TO : All Bidders
FROM : Mark Graham
PROJECT : Rio Vista Elementary School Modernization
Project 1719800.41
SUBJECT : Addendum 1
DSA : 04-118156 / File 36-55

1. ADD ALTERNATES

FINISH - NEW FIRST FLOOR PLAN - BLDG A1 Copy 1	1/8" = 1'-0"	2
--	--------------	---

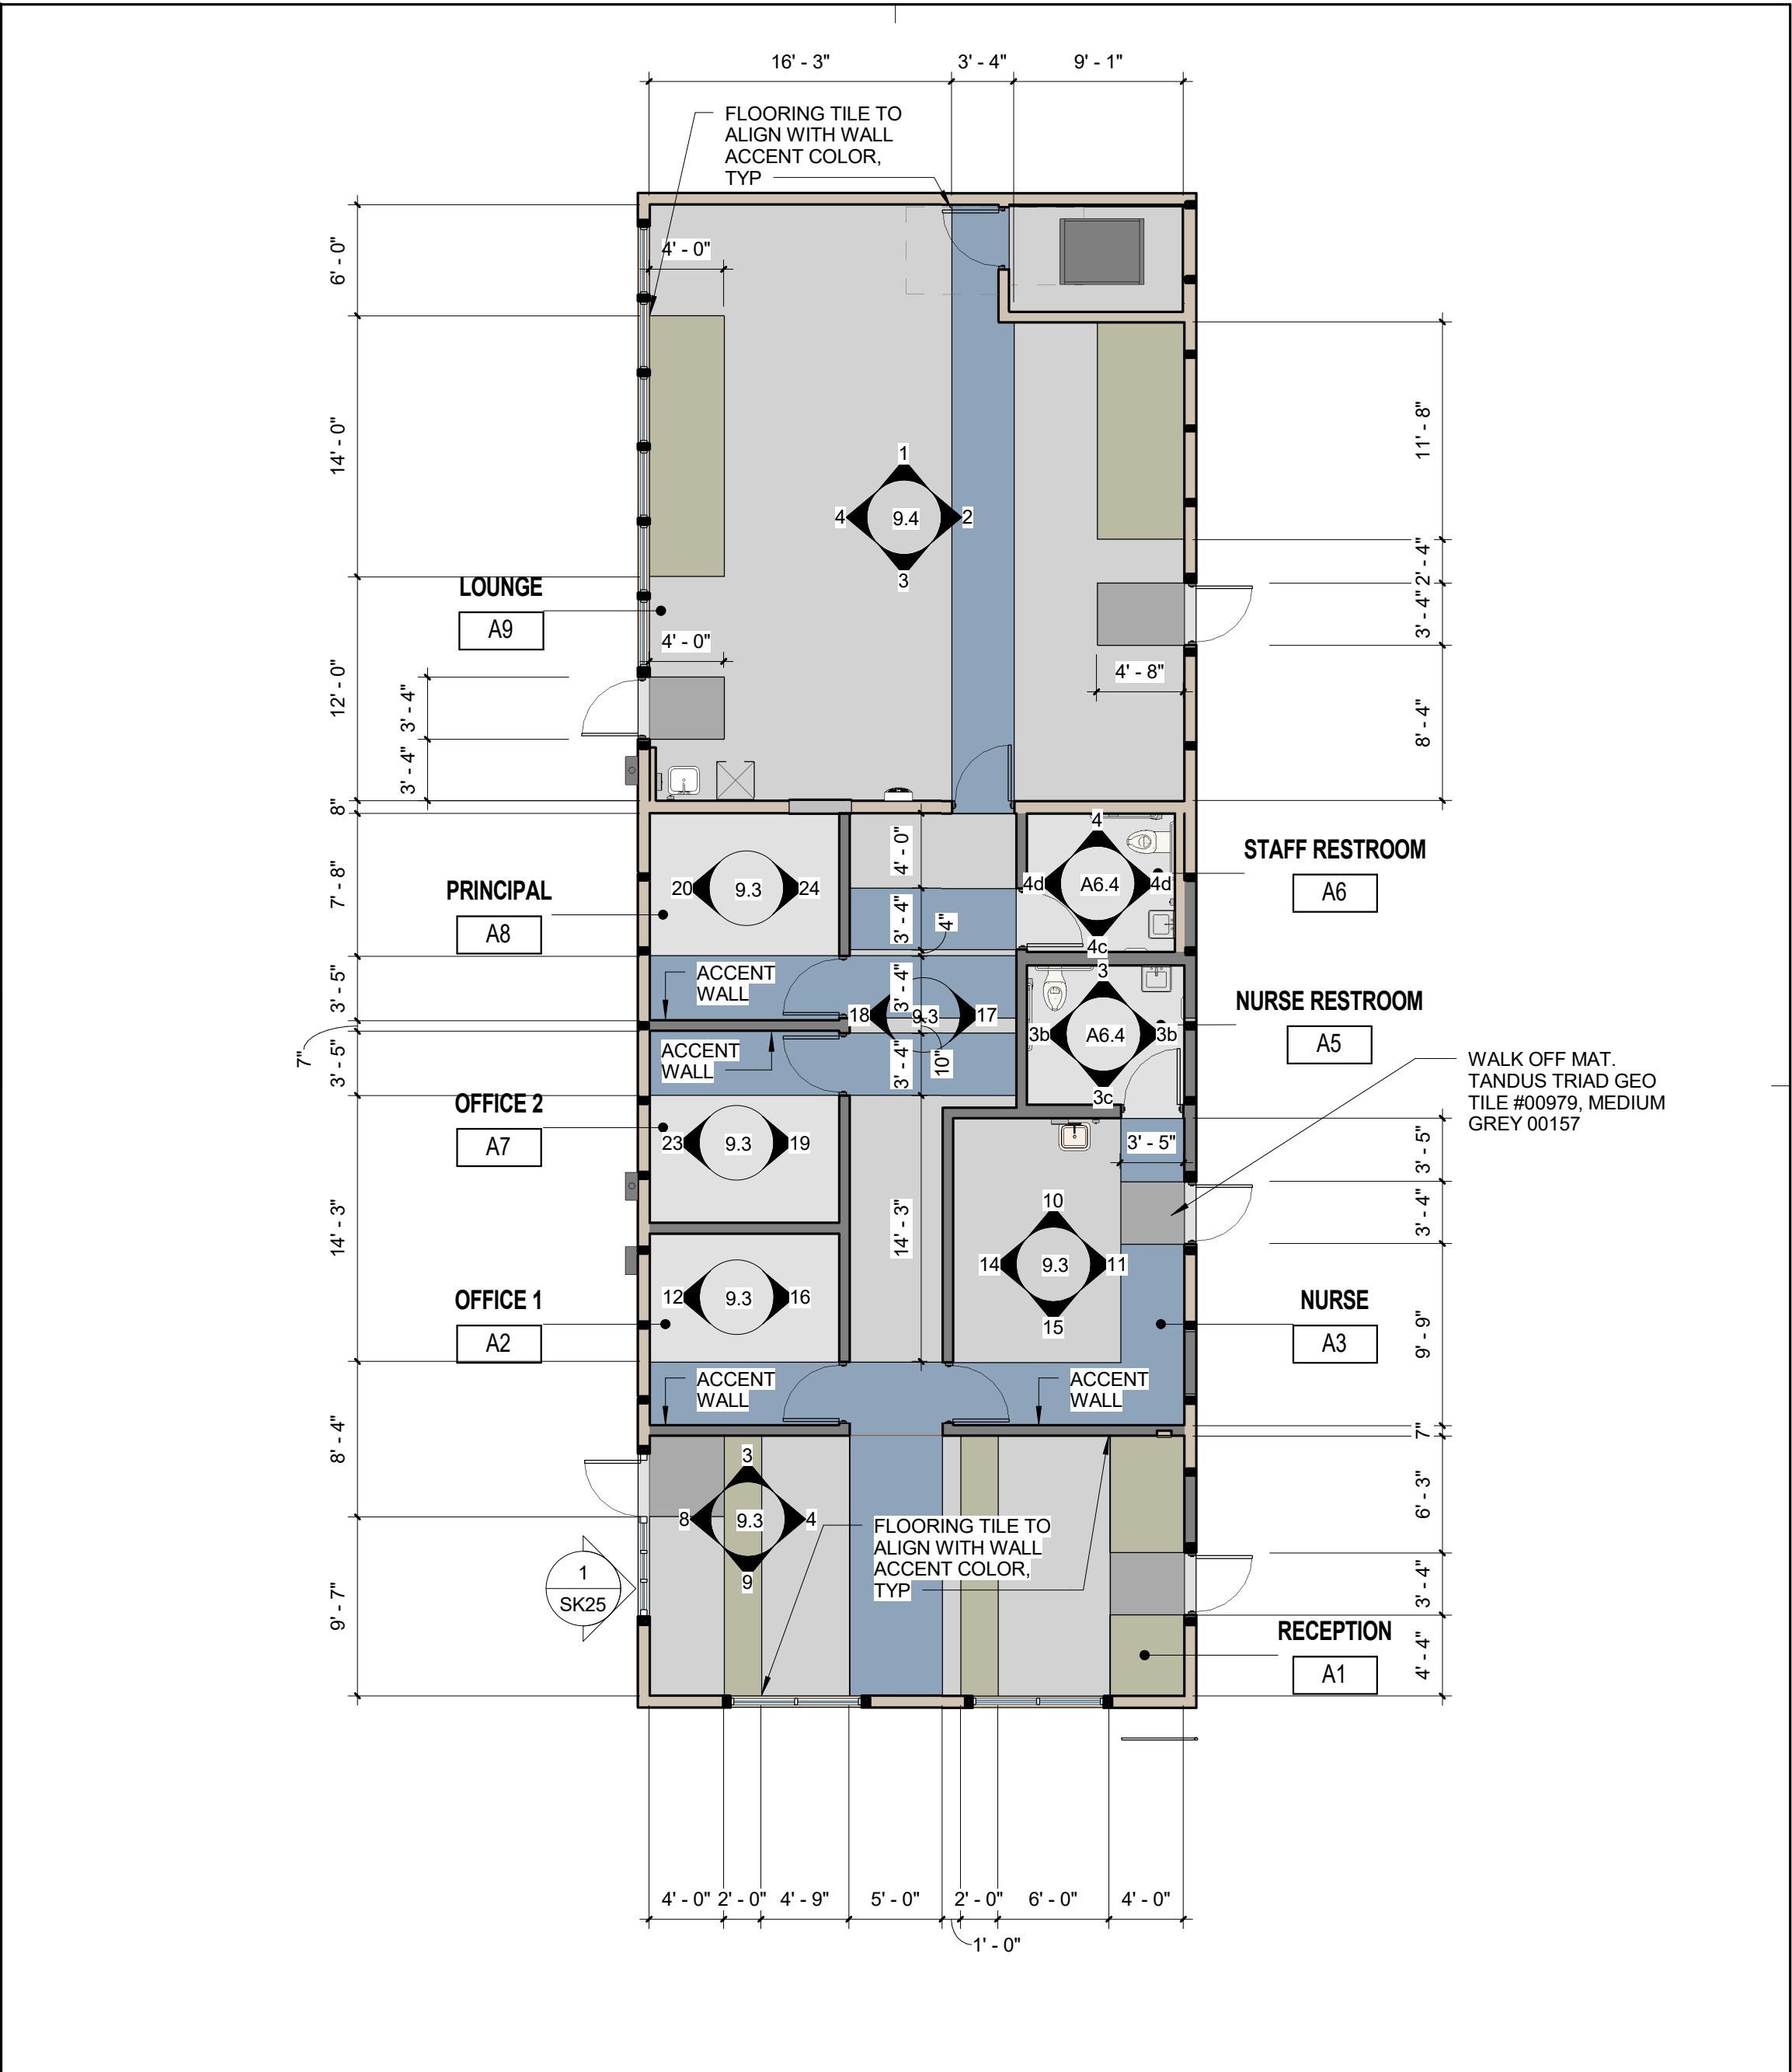
fire bell detail needs to be placed on 9.4

SK1

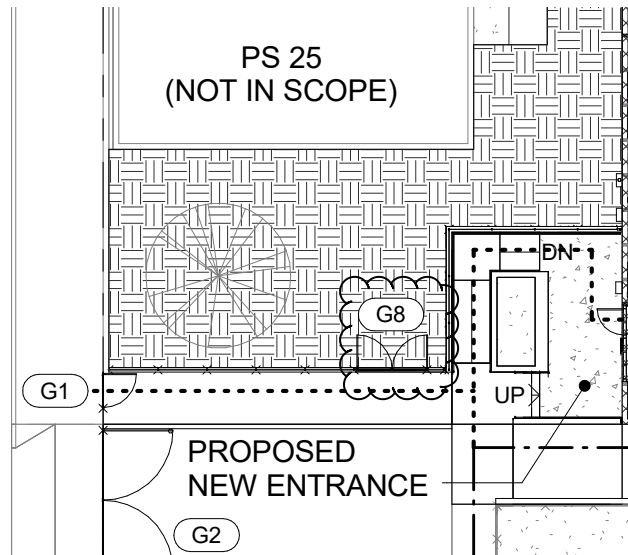
1.33 DRAWING A1.1

- A. Detail 1
 - 1. Revise drawing per attached SK1.

SK2

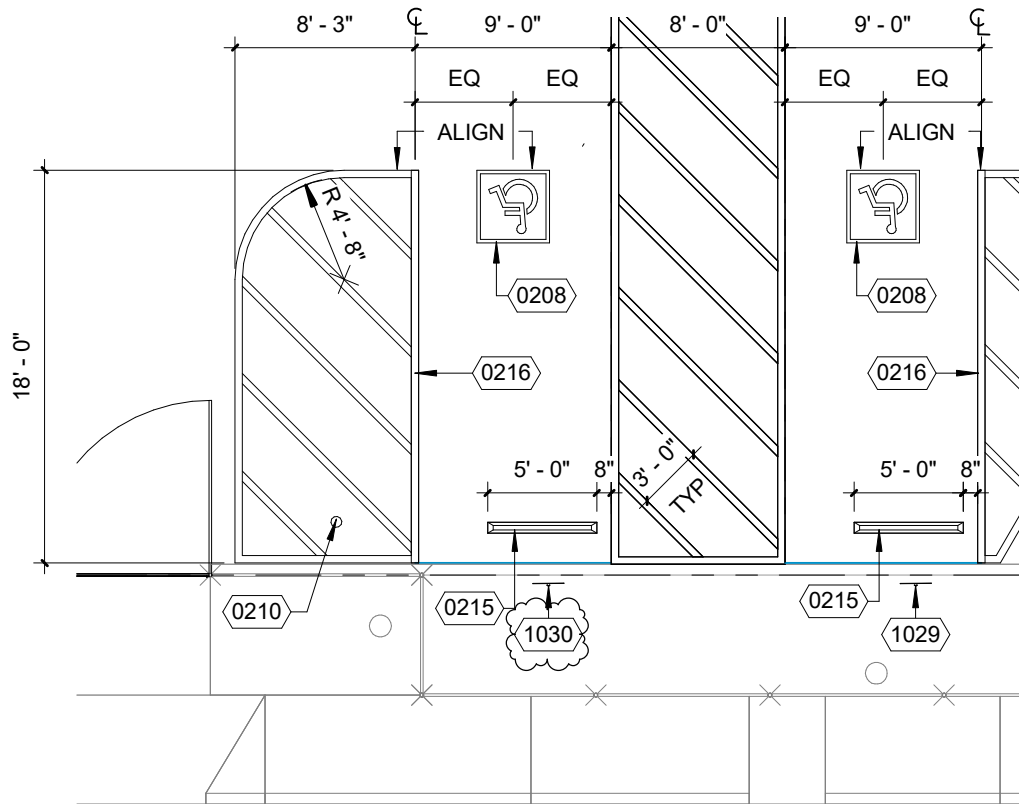
1.34 DRAWING A1.2

- A. Detail 3
 - 1. Revise Note 1029 on accessible parking stall to 1030 per the attached SK2.

SK3

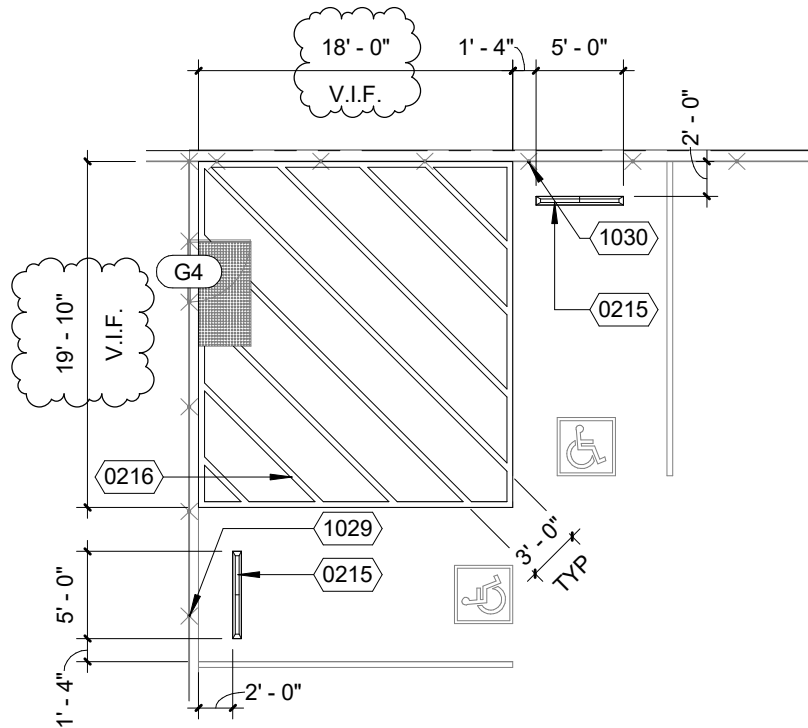
1.36 DRAWING A2.3

- A. Detail 6
 - 1. Add dimension to parking lot striping per attached SK3.

SK4

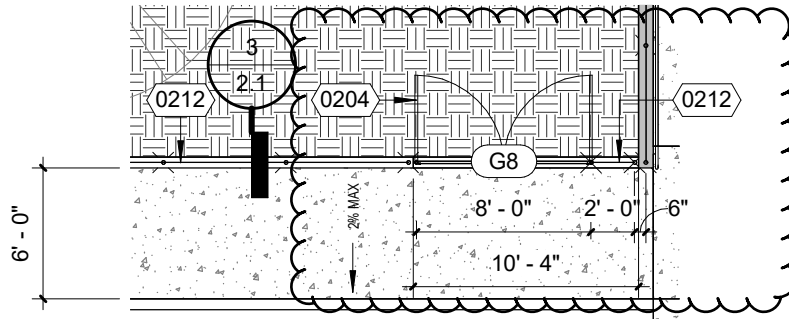
1.37 DRAWING A2.4

- A. Detail 1
 - 1. Delete Ref Note 0124 at northeast corner of building.
 - 2. Add Note 0124 and leader to electrical box that is west of "OFFICE 1" on exterior wall.
 - 3. Revise "5'-0"" to "6'-0"" for new AV STOR. Room dimension for north/south dimension.
 - 4. Add a pair of 3'-0" gates as shown in attached SK4. Gate shall be 6'-0" high and used for maintenance operations only. See similar details from 19/2.1.

ADD-01
SK5

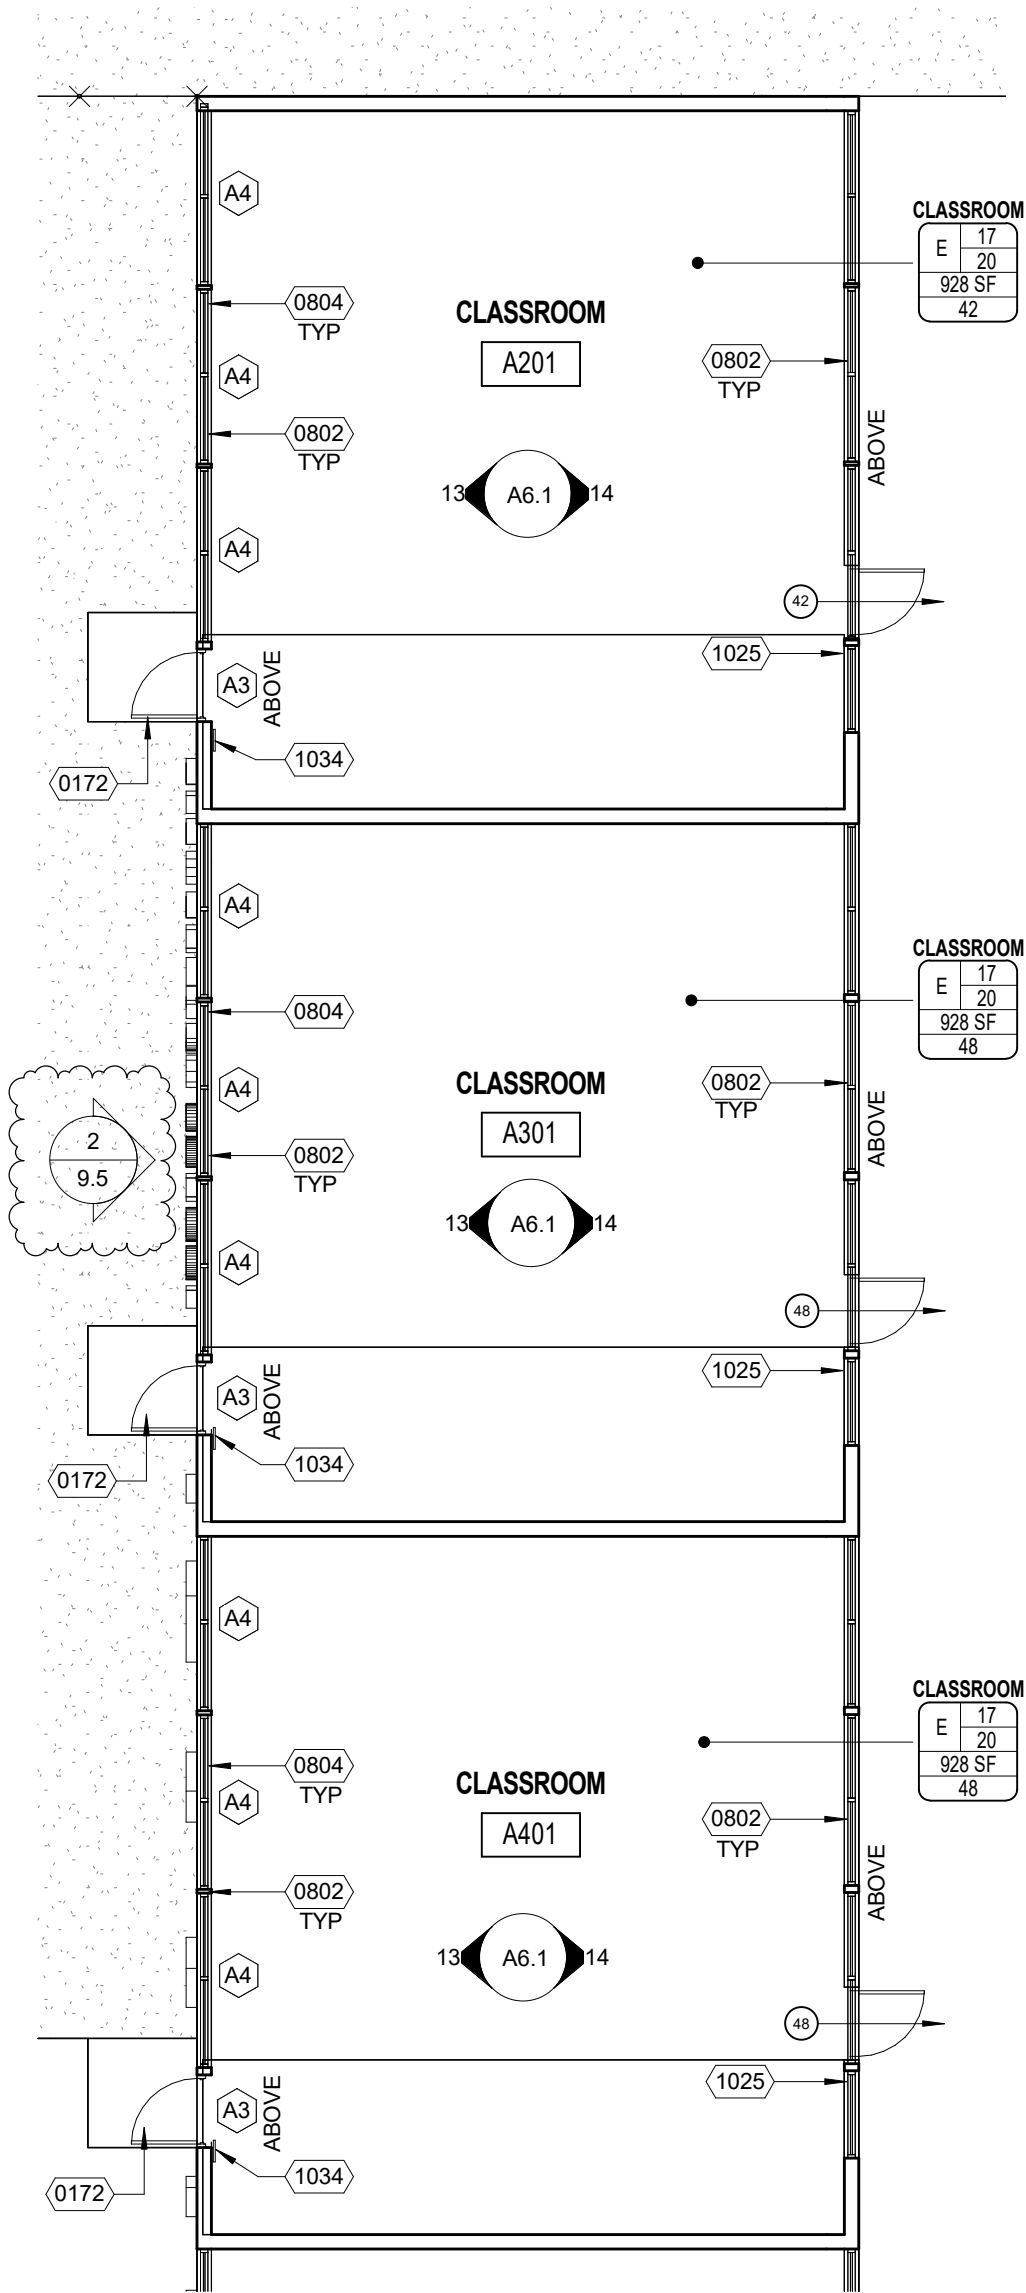
B. Detail 2

1. Revise sketch per attached SK5.
